ADDENDUM No. 1

RFP No. 25-10

WESTGATE WATER MAIN PROJECT

CITY OF ANN ARBOR - PUBLIC SERVICES - ENGINEERING
WESTGATE WATERMAIN
SE WATER MAIN ROUTE
HYDRANT H2 & 2503 JACKSON AVE SERVICE LEAD

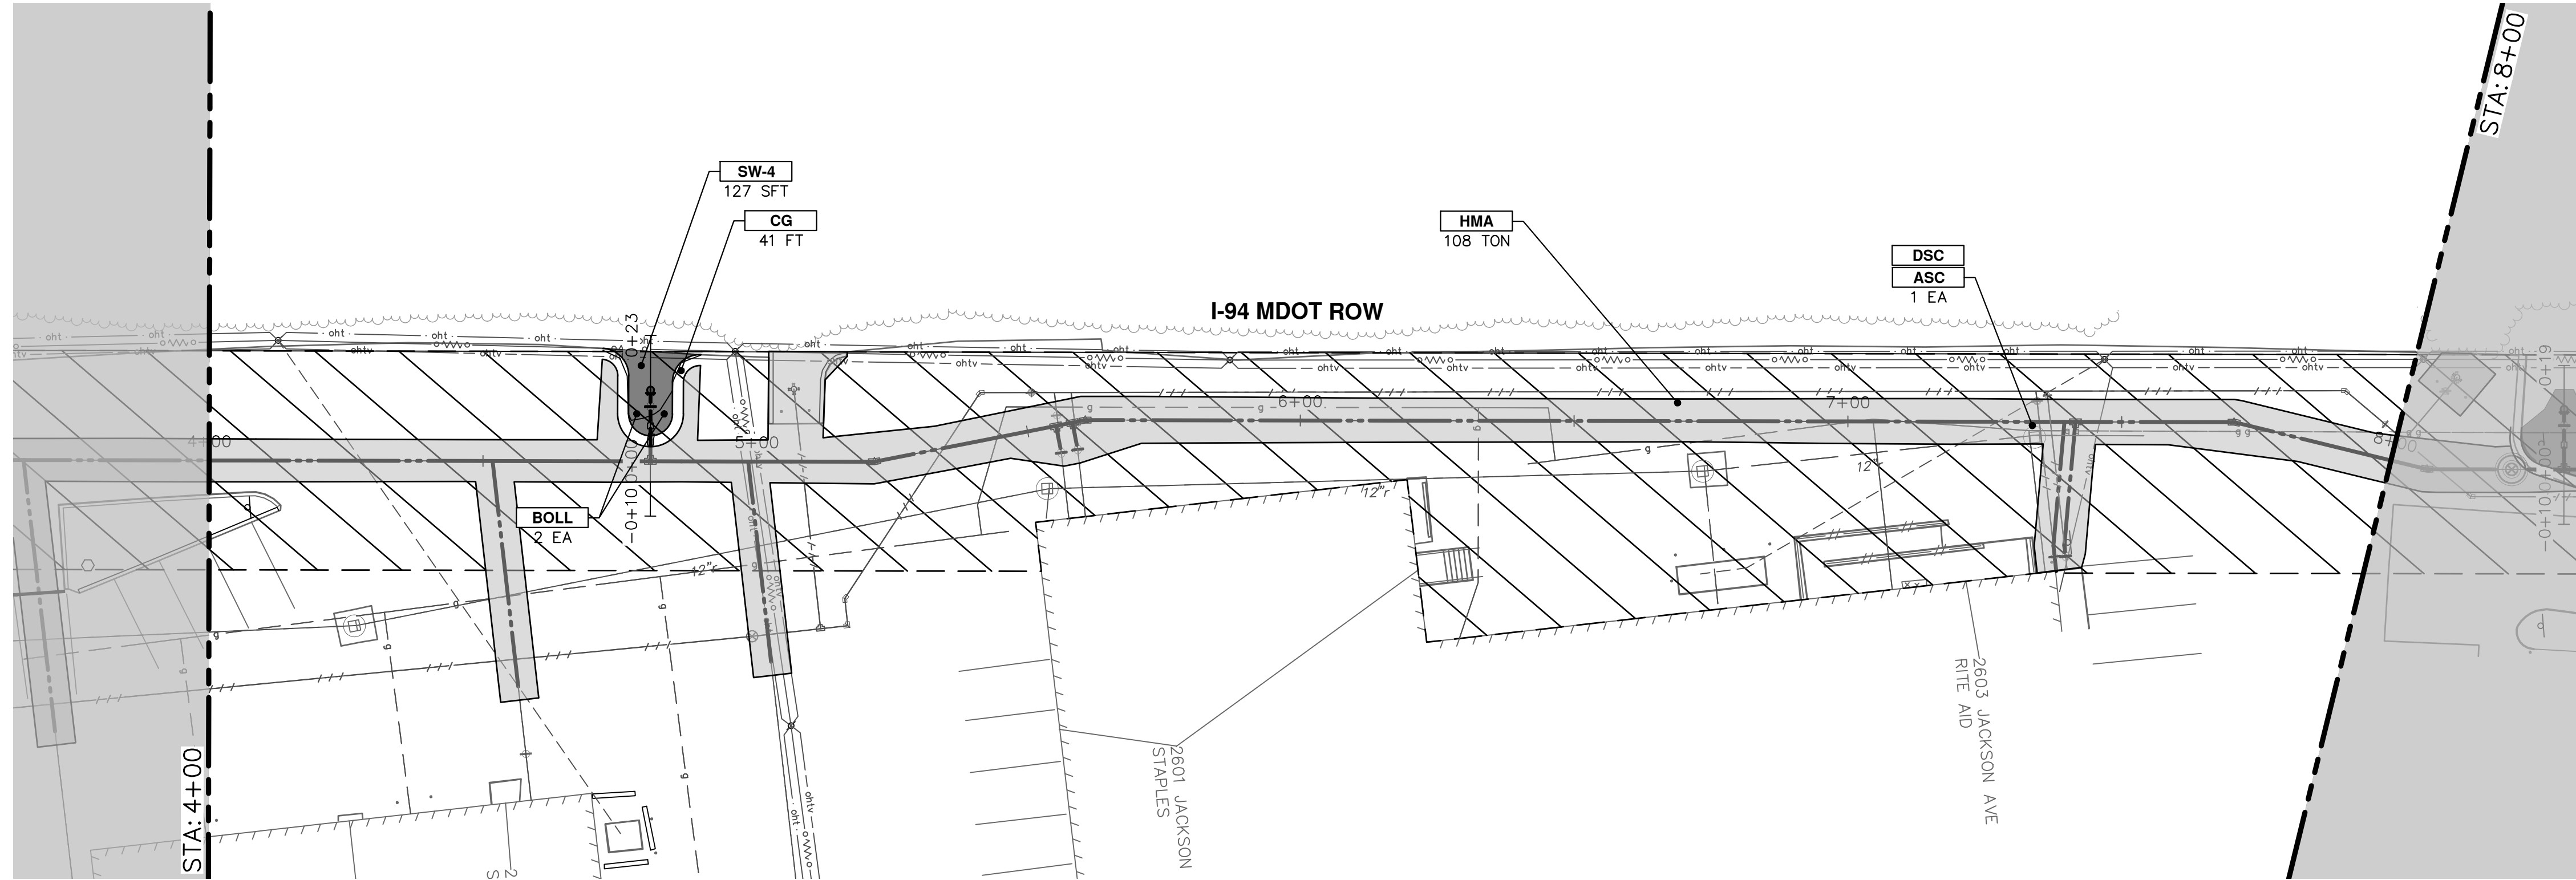
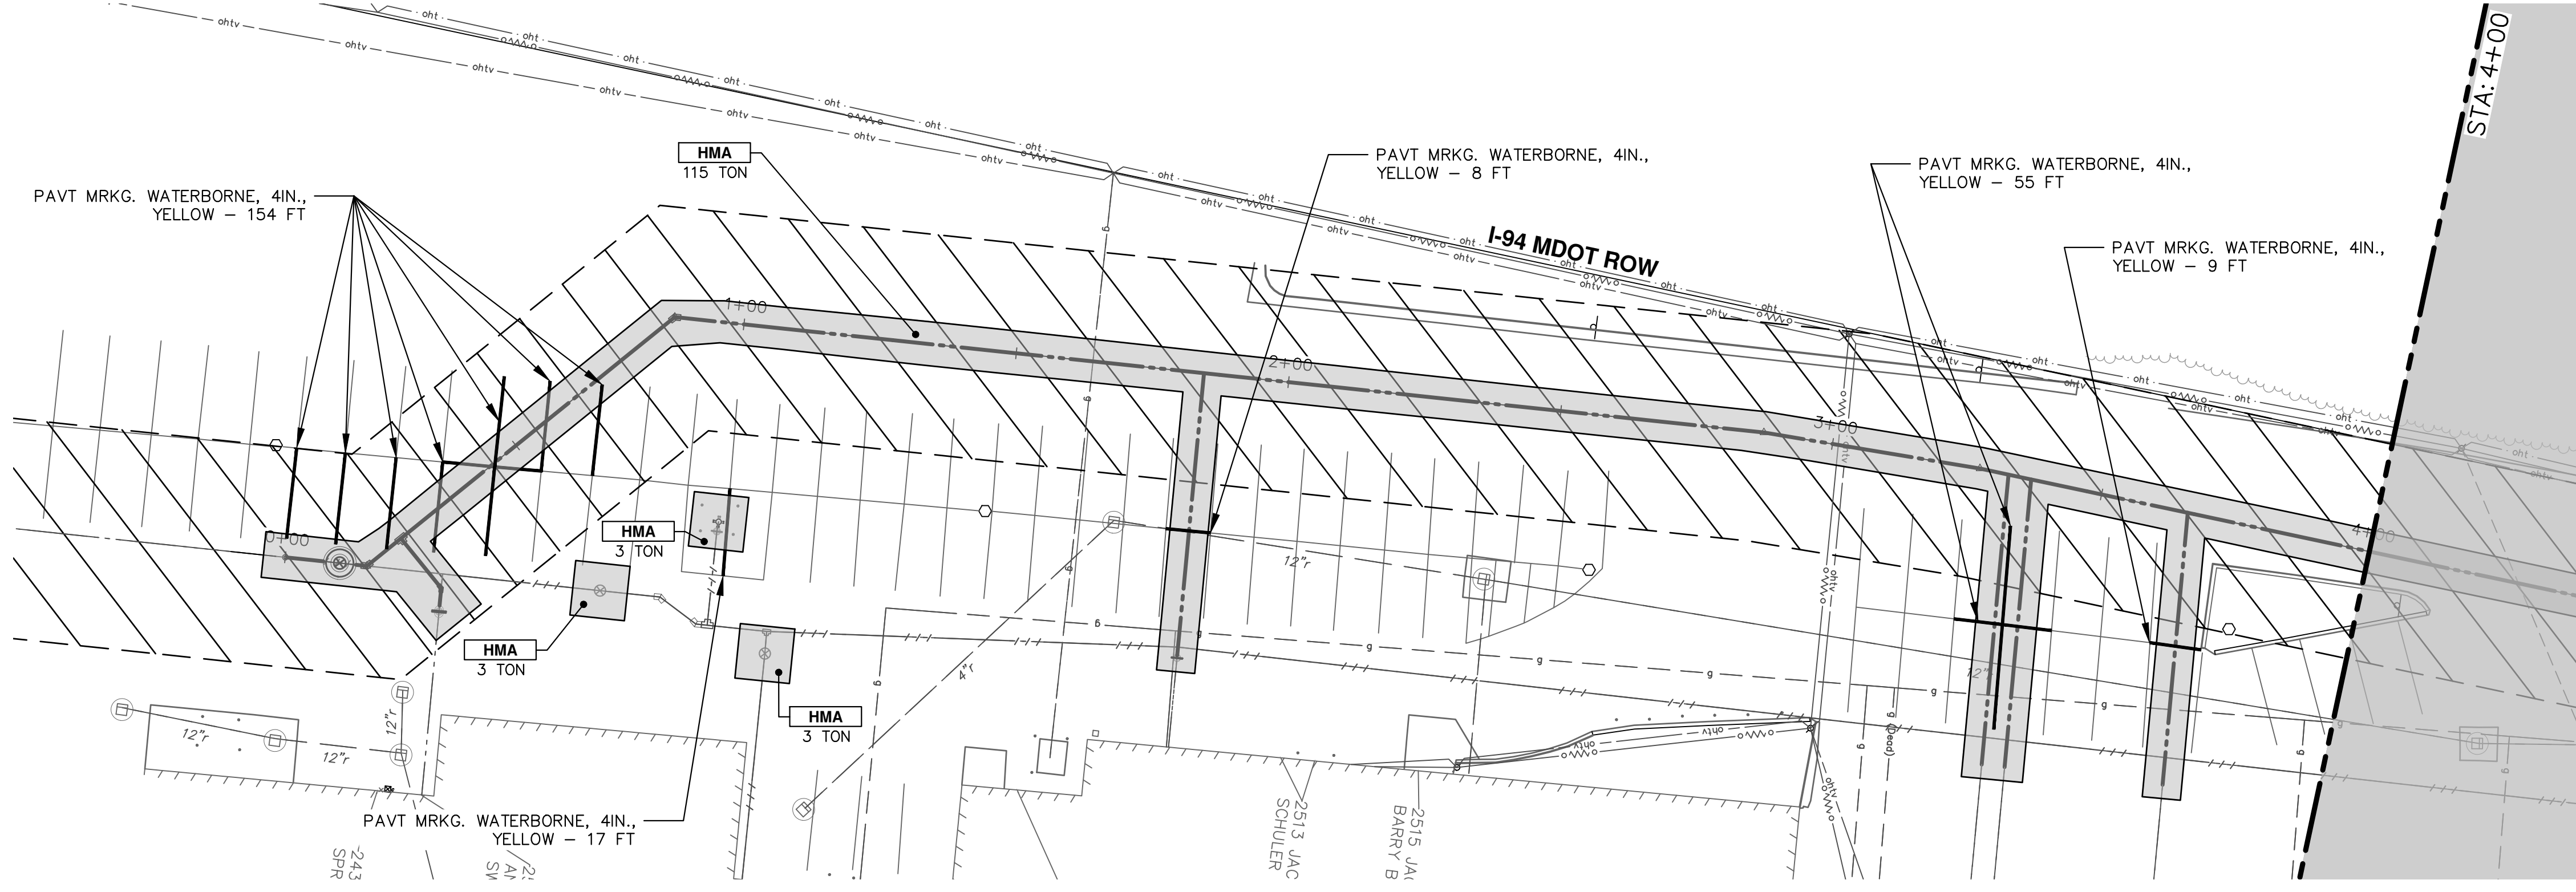
Question 41: The Detailed Special provision for the direction drilled copper service specifies the material to be copper. For this application and length, it is not advised or recommended by suppliers to use this material. Two-inch copper comes in 60' rolls and will require multiple silver solder joints. Can alternative material be specified for this work? A typical industry standard water service material used for directional drill applications is HDPE SDR-9 CTS. It also comes in lengths that are longer than the bore length resulting in a jointless run of pipe.

Answer 41: The Detailed Special Provision for directional drilled service has been revised and included in this Addendum as DS_2 In., HDPE Water Service, Directional Drill. Instead of copper, we recommend HDPE. Service lead material is noted on Sheet 32.
